ELECTRONIC REVIEW STAMP - DOCFLOW AI (POC)

SP ENGINEERING (MAIN CONTRACTOR)		
CoolAir HVAC Systems (Subcontractor)		
PROJECT: SPCL		
TITLE		
Material Approval Request - VRF Outdoor Units (Daikin VRV-X)		
DOCUMENT NO.	REV	SCALE
SPCL-MEP-MAR-0203-A	A	NTS
TYPE	DATE	
Submittal/MAR / MEP	2026-06-08	
STATUS		
[APPROVED W/ COMMENTS]		
FILE: VRV-X-datasheets.pdf

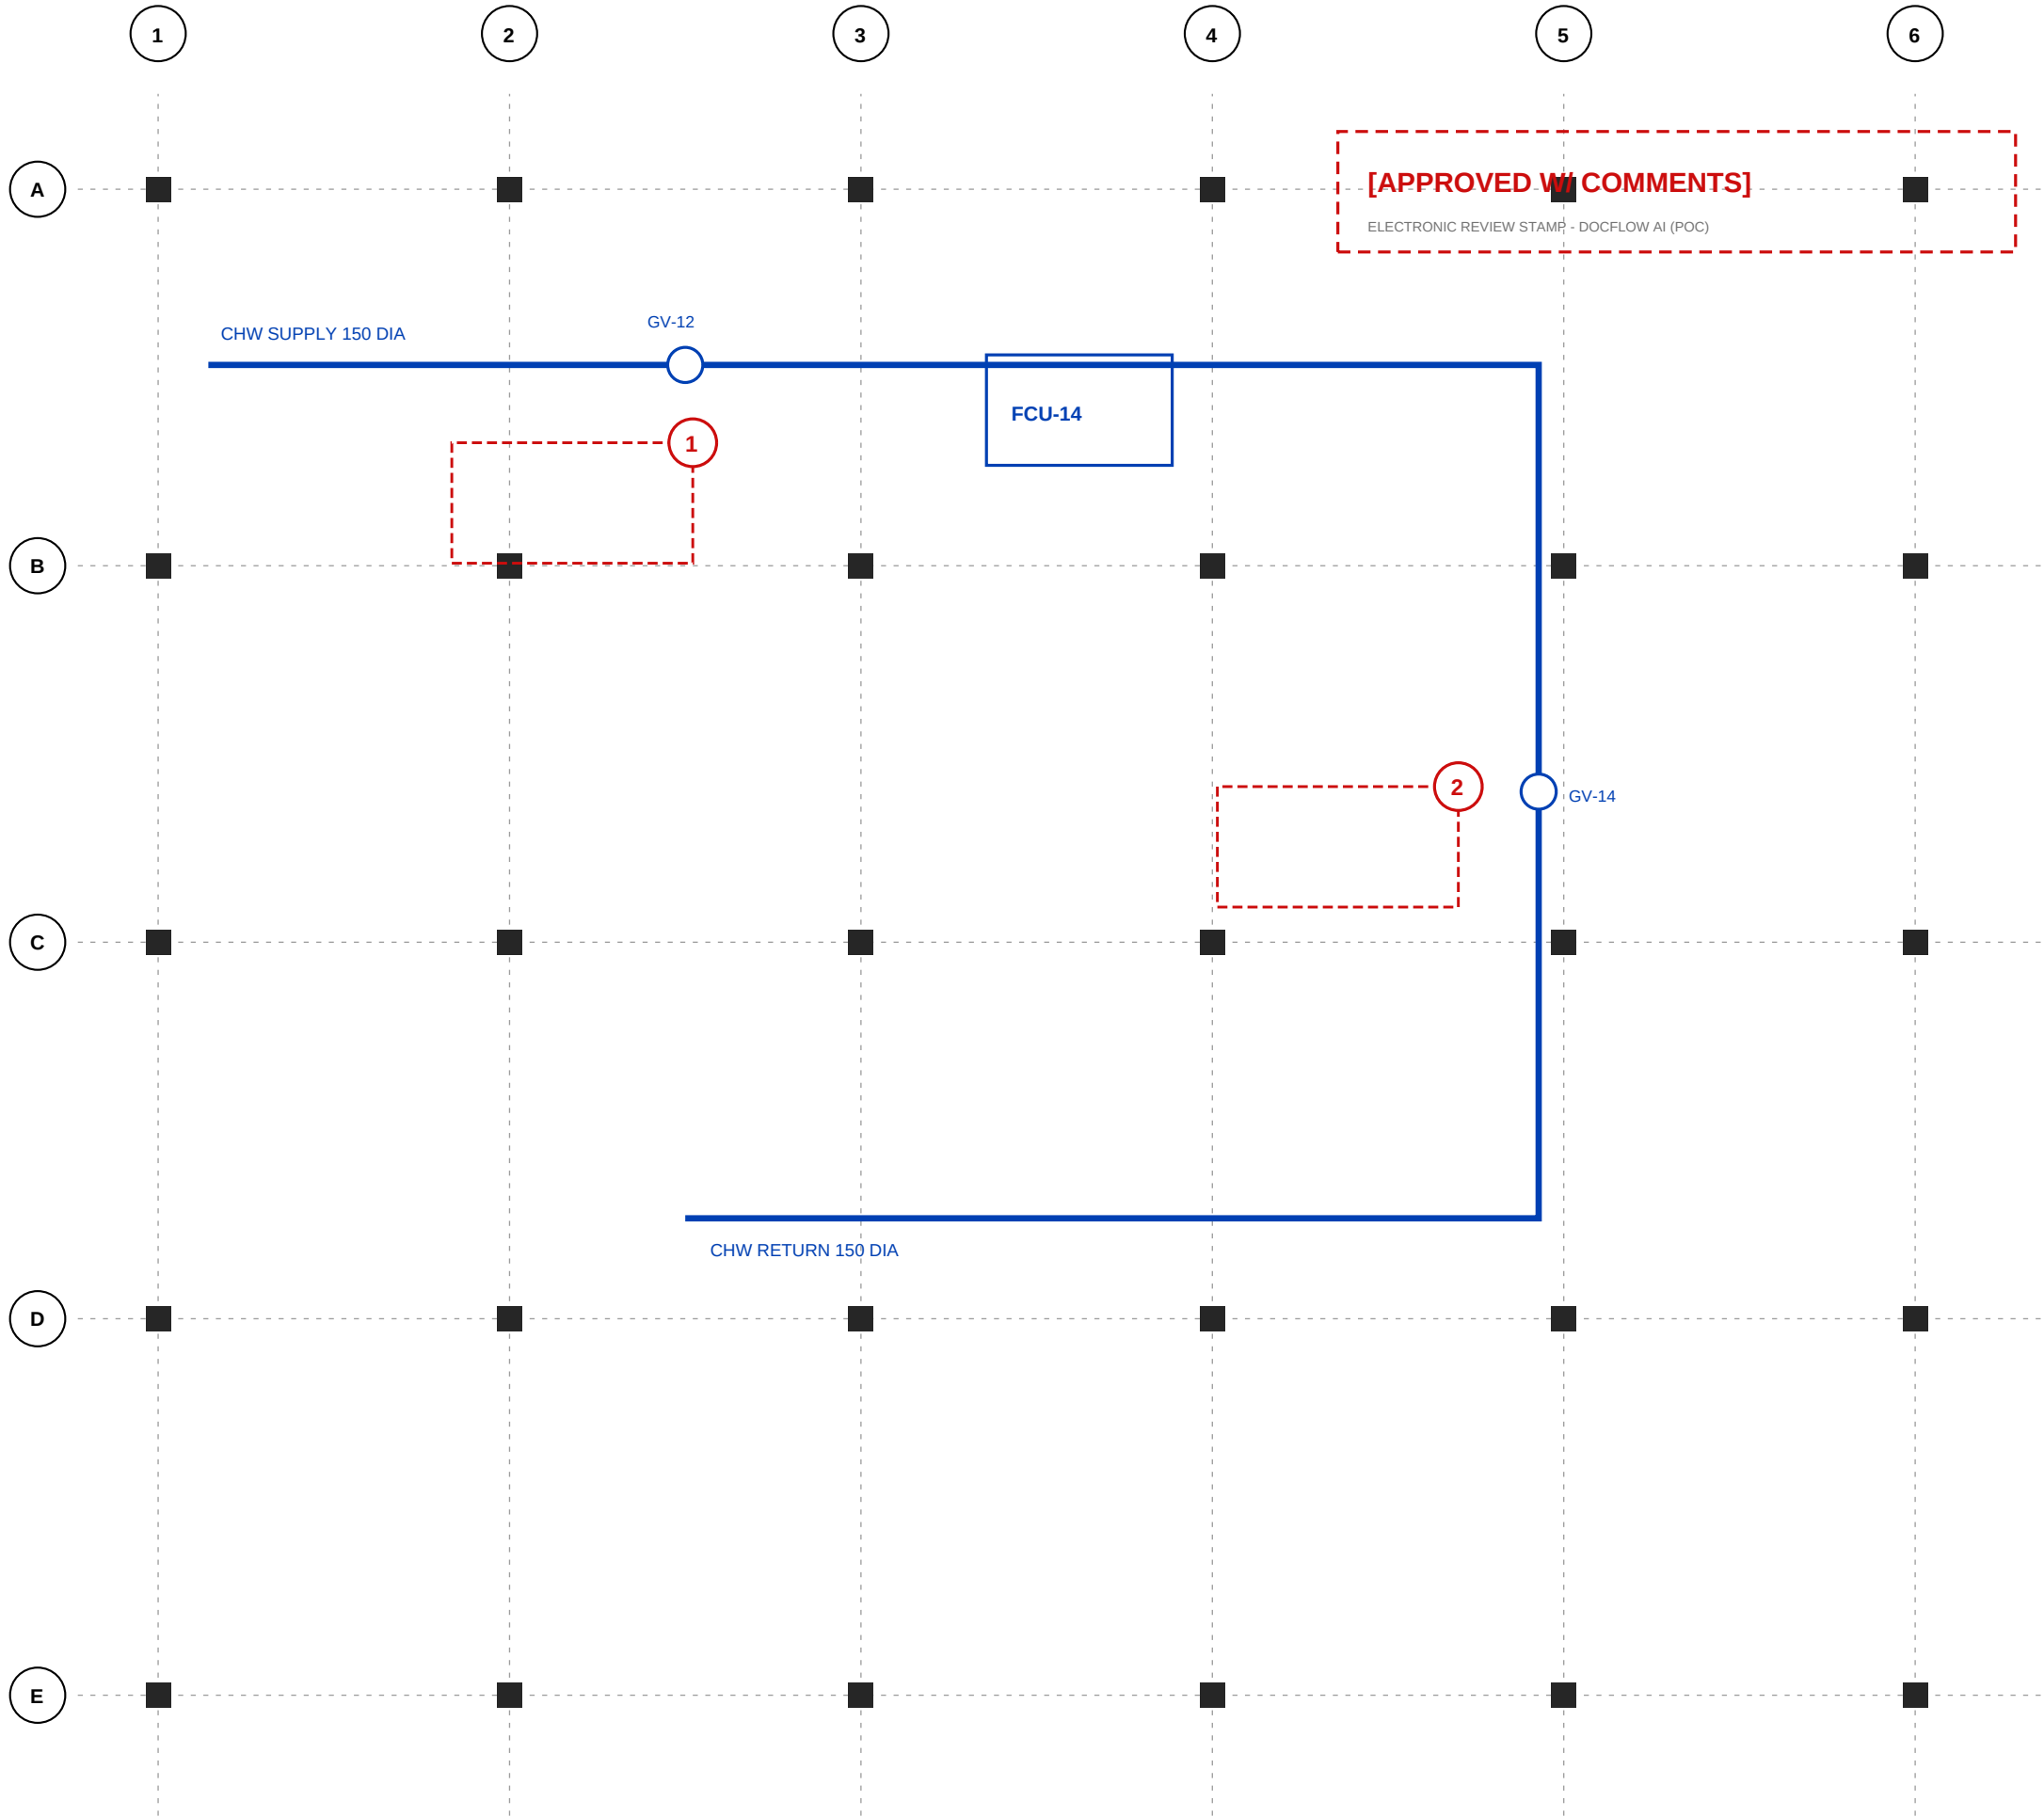
Code 2. Approved with comments: submit type test certificates for L14+ units before delivery; confirm refrigerant pipe lengths within manufacturer limits for roof-mounted condensers.
- 2

Noted. Test certificates to follow under separate submittal by 30-Jul.
